## Structural Evaluation Report

**Date:** November 16<sup>th</sup>, 2022 **Project: No.** 747022  
**To:** Burkhardt Gilchrist Architects  
**Attn:** Ruth Burkhardt  
**Re:** Structural Evaluation – 7989 Brooke Line #7 – Brooke Central P.S., Alvinston, Ontario

Re: Structural Evaluation  
7989 Brooke Line #7 - Brooke Central P.S.  
Alvinston, Ontario  
Brooke Central Public School  
Date: Wednesday, November 16, 2022

- Figure 1 is the Structural Drawing No. S1 for the 1960 Building, and
- Figure 2 is the Structural Drawing No. S1 for the 1967 Building Addition.

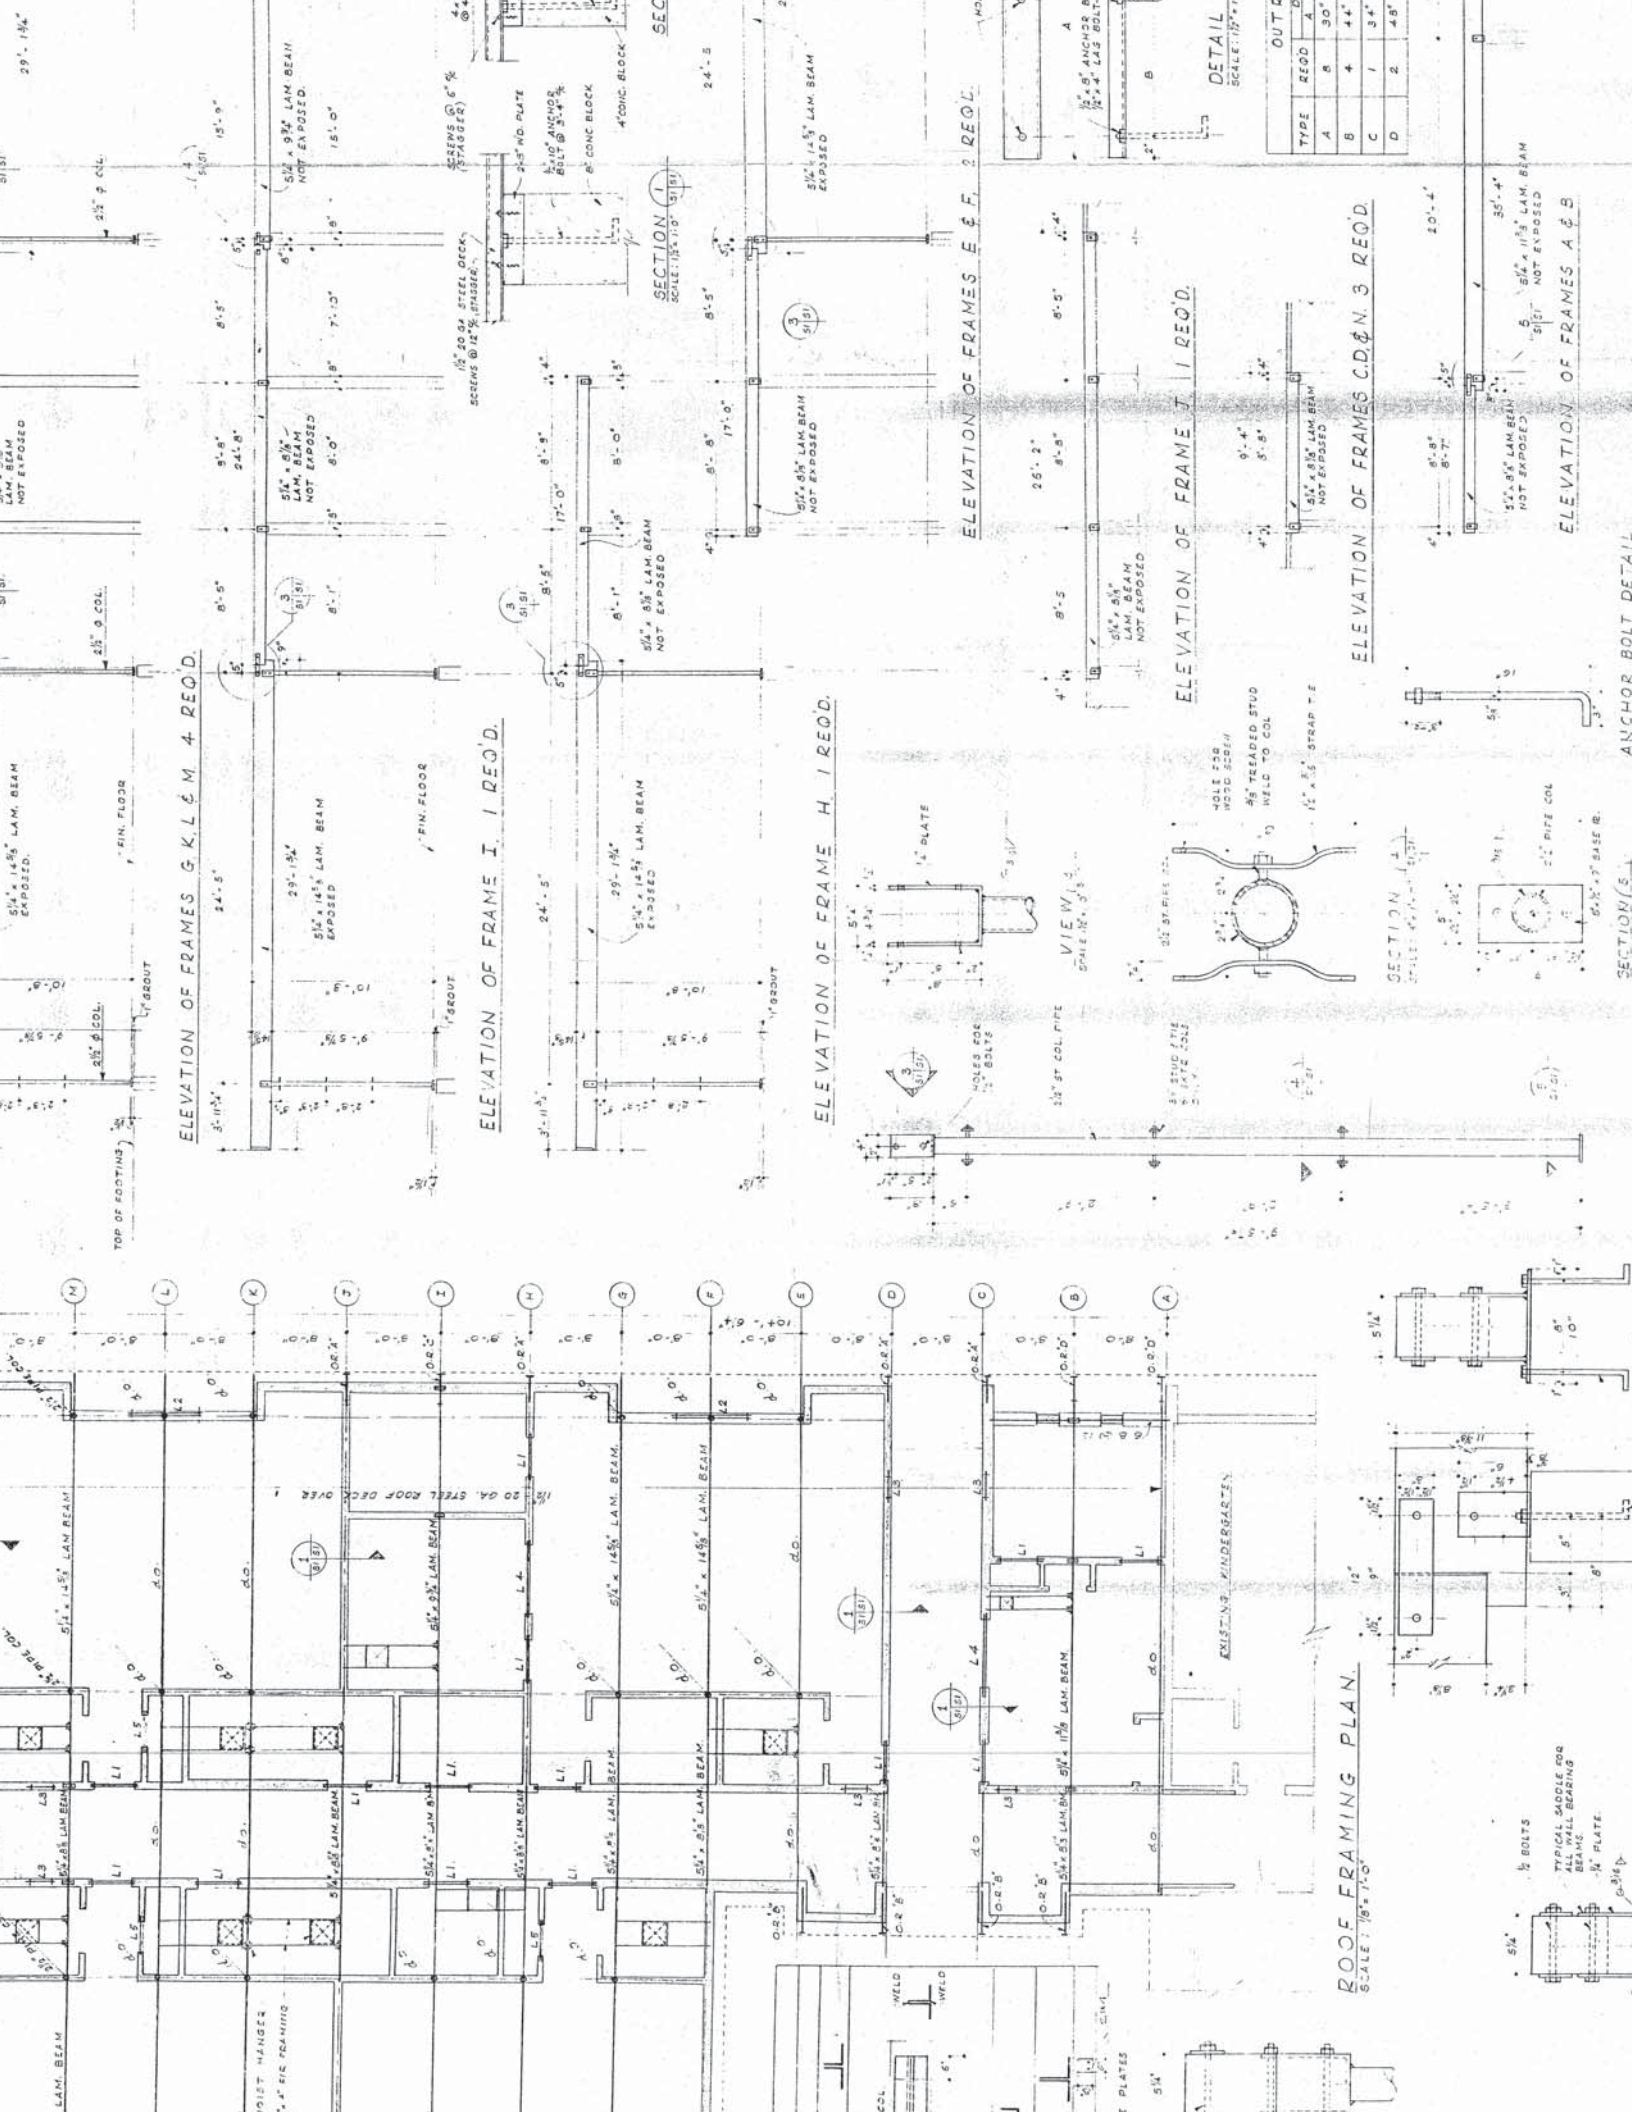
The 1960 building is the original building constructed at the site. The roof is framed with glulam beams supported by either wood or steel columns or beams, or supported by the exterior load bearing wall (see Figure 1 on Appendix 'A').

Note on Figure 1 that most of the Frames Type 'A' are affected by the snow drifting. The Snow drifting is extended over approximately 19'-2" along the smallest cross section of the beams. Additionally, intermediate steel reinforcement has been added between some of these beams along the West and East sides of the building. The steel beams reinforcement spans only from block wall to block wall which is where the larger cross section of the beams are located. The reinforcement is not extended over to the cantilevered portion of the beam or the small cross section of the beam

Note on Figure 1 that there is an area at the North side of the building that had an upgrade done in 2013. A portion of the block wall was removed along the location shown on the drawing and was replaced with two steel beams supported on steel columns and channel outriggers framed to the North of the steel beams. In order to do this the cantilevered portion of Frames Type 'B' and 'C' had their cantilevered portion removed.

APPROXIMATE EXTENT  
OF SNOW DRIFTING

19'-2"  
(5.84m)

It is concluded that it is not feasible to change the roof construction at the Original 1960 Building and the 1967 Building Addition. Roof insulation should not be upgraded with a thicker insulation nor should be it be upgraded with an insulation with an equivalent thickness: A new and equivalent insulation to the existing thin insulation will be more efficient and will then prevent the building's heat loss and hence snow melting in the roof.
